**To: All Vendors Bidding on The College of New Jersey
2020 Paving Project**

ADDENDUM NO. 1

REFERENCE: The College of New Jersey
2020 Paving Project
Bid No. AB200009

Lot 4

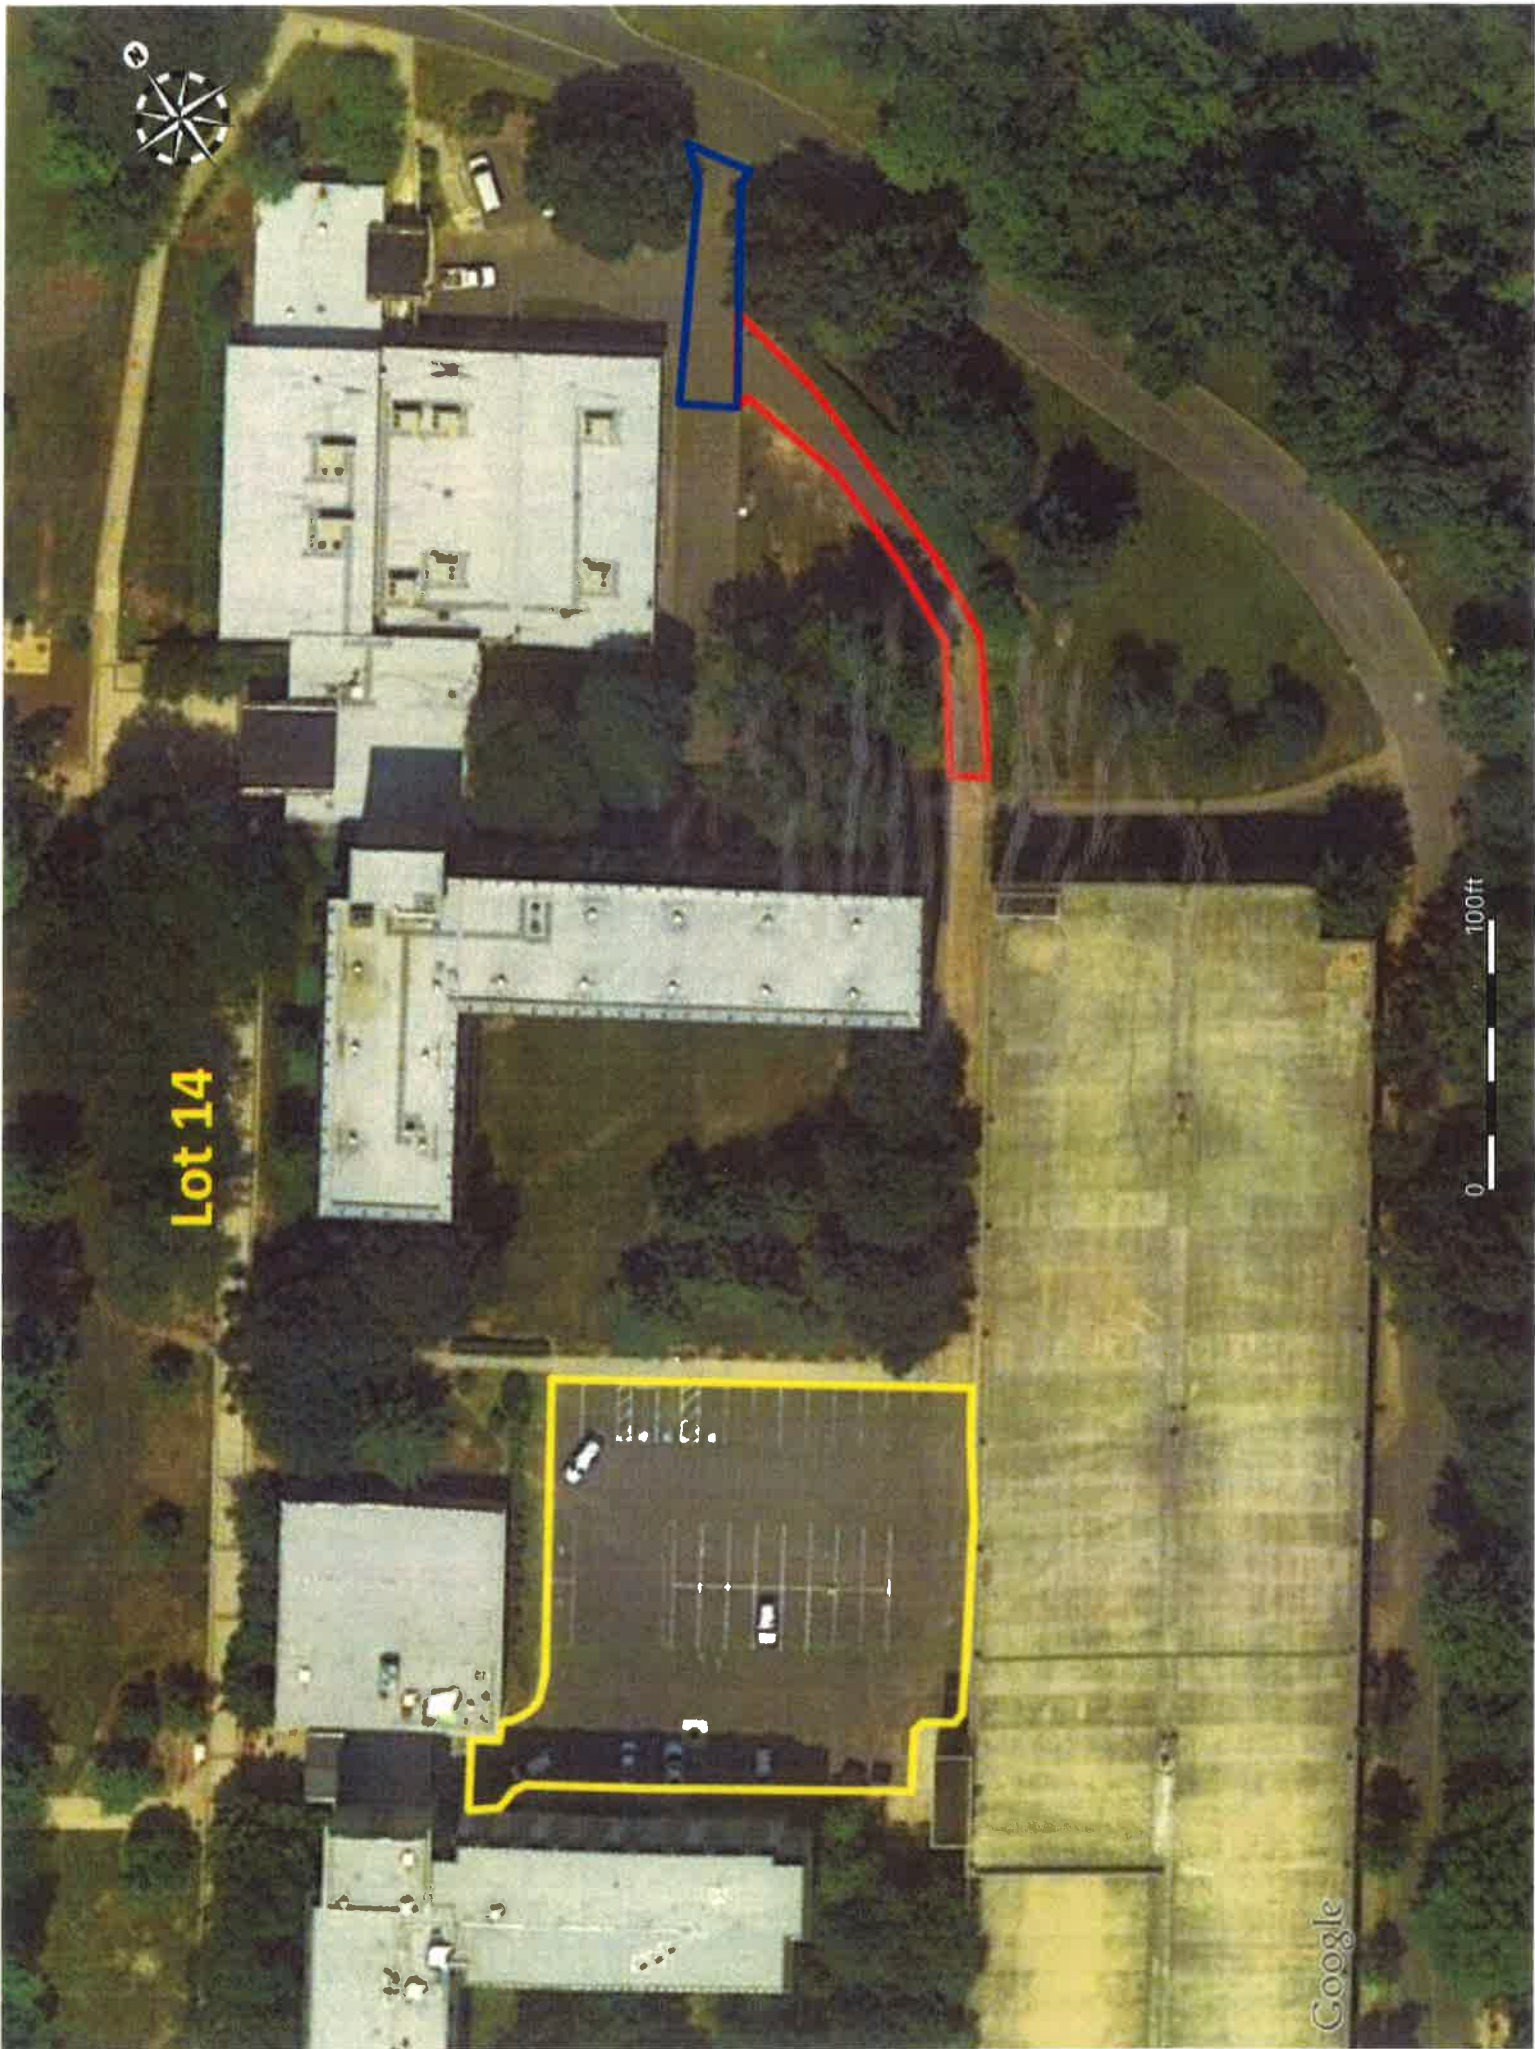
2. I wanted to clarify that I have the correct limits outlined for Lot 4 as well.

3. Another question I had was in reference to the concrete curbing. In my inspection I noticed (2) sections in Lot 14 totaling around 60LF. I did not notice any markings in Lot 4 (could have been under cars). The RFQ calls out 15LF, is this all in one continuous curb? And where is the approximate location(s)?

Curb
REPLACEMENT

Response: Lot 4 to be paved up to Metzger Drive. Contractor is to remove existing sensors in ground and coordinate install of new sensors at gates. The scope of work to include remove and place parking gate operator sensors embedded in the driveway with new sensors. Three sensors total: 1) entrance; 2) exit. Vendor is Baxter & Associates. Contact is Fred Baxter, baxterassocinc@aol.com, 732-946-2800. All costs associated with the removal and install of the new sensors in ground, labor and material, should be included in the base bid price.

Response: See marked up map for approximate location of continuous curbing to take place.
